Access Compliance Report

Public Rights-of-Way

(Curb Ramps)

Intersection ID: 17870	Main Street: HILLSDALE_AV	Cross Street: TRANQUIL_AV	Location: SE
ADA ID: 5D0707EE4911	Ramp Type: Perp	Initial Pass/Fail: Fail	Overall Compliance: No
Severity Score: 61.25			
Codes/Mitigation Info/Possible Solution		Field Measurements/Component Compliance

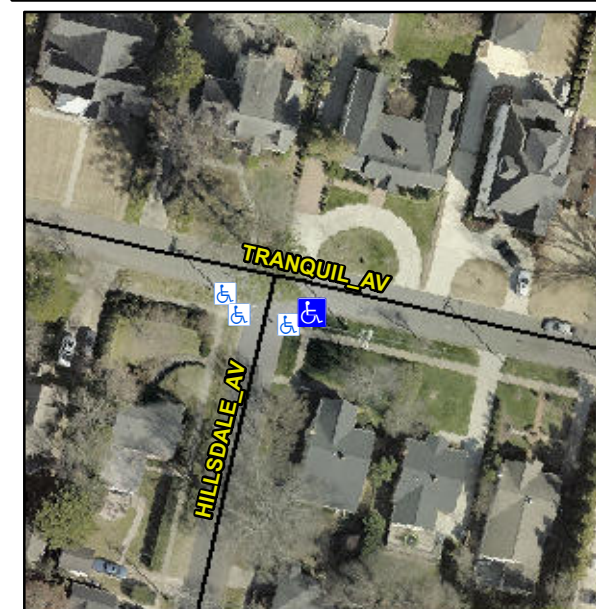
Not Found, R304.5.1, R304.2.2, R304.5.3, R302.7

Compliance	Description	Data	Compliance	Description	Data
N/A	Ramp Length (in)	55.0	No	Ramp Slope (%)	8.8
No	Ramp Width (in)	38.0	No	Ramp XSlope (%)	10.2
N/A	Flare Type LT	N/A	N/A	Flare Type RT	N/A
N/A	Flare Slope LT (%)	N/A	N/A	Flare Slope RT (%)	N/A
N/A	Flare Traversable LT?	N/A	N/A	Flare Traversable RT?	N/A
N/A	Landing Length (in)	N/A	N/A	DWS Provided?	N/A
N/A	Landing Width (in)	N/A	N/A	DWS Contrast?	N/A
N/A	Landing Slope (%)	N/A	N/A	DWS Length (in)	N/A
N/A	Landing X Slope (%)	N/A	N/A	DWS Full Width?	N/A
N/A	Landing Curb? (Y/N)	N/A	N/A	DWS Offset (in)	N/A
N/A	Shared Landing?	N/A			
N/A	Gutter Ponding?	N/A	N/A	Gutter Slope (%)	N/A
N/A	Gutter Lip Ht (in)	N/A	N/A	Gutter X Slope (%)	N/A
N/A	Painted X Walk1?	No	N/A	Painted X Walk2?	N/A
	X Walk 1 Direction	To NE		X Walk 2 Direction	N/A
N/A	X Walk 1 Width (in)	N/A	N/A	X Walk 2 Width (in)	N/A
	X Walk 1 Slope (%)	2.1		X Walk 2 Slope (%)	N/A
	X Walk 1 X Slope (%)	7.0		X Walk 2 X Slope (%)	N/A

N/A	Ramp inside XWalk1?	N/A	N/A	Ramp inside XWalk2?	N/A
	Road Slope (%)	N/A	N/A	Clear Space?	N/A
	Road X Slope (%)	N/A	N/A	Clear Space to XWalk (in)	N/A
N/A	Any Obstructions?	N/A	N/A	Storm Grate/Utility Hazard?	N/A
	Obstruction Type			Storm Grate/Utility Type	
		N/A			N/A
		No		Surface Condition? (G/P)	Poor

Remove & Replace Entire Ramp.
